Radiation Safety Office

June 27, 2005

ANNOTATED RESPONSE

CHEVRON SCIENCE CENTERS
NINTH FLOOR PLAN

NINTH FLOOR PLAN
SCALE: 1/8" = 1'-0"

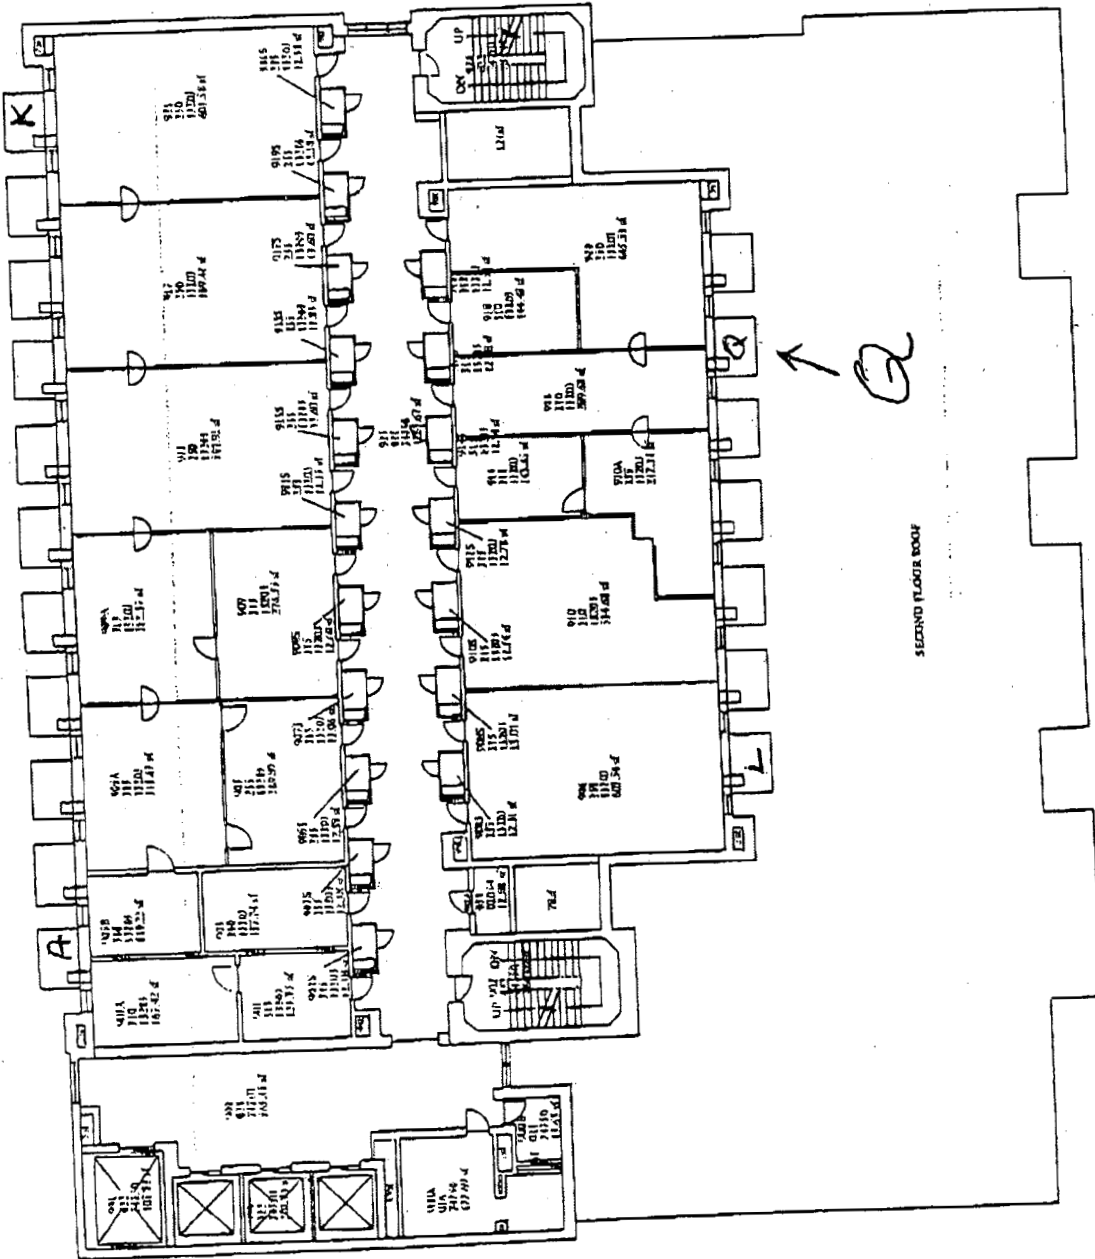
2. Provide diagrams of the facility designed for handling this tritiation device (e.g., dedicated synthesis facility with device installed in a fume hood). Include schematic descriptions of the ventilation system, with pertinent airflow rates, pressures, filtration equipment, and monitoring instruments. Diagrams should be drawn to a specified scale, or dimensions should be indicated.

The room dimensions are 30 ft. x 9.5 ft. x 8.67 ft. (see attached drawing) There are 3 entries. The two side entries will remain locked from the inside. All doors will be posted.

The Trisorber will be installed in a dedicated fume hood. There are 18 air discharge risers external to the building. They feed two roof plenums and fan units. The riser labeled "Q" is associated with the laboratory in question. There is no filtration system on the discharges. The ventilation system has been newly refurbished.

There are two hoods in the laboratory each designed to draw 850 cfm. Make-up air is

supplied at a rate of 1100 cfm. The air turnover rate is approximately 40 per hour. At this rate it would take approximately 10 minutes for a 1 curie release into the room to reach the DAC. A spilled gas clearance time of twenty minutes will be posted. The room will be maintained at a negative pressure relative to its surroundings.
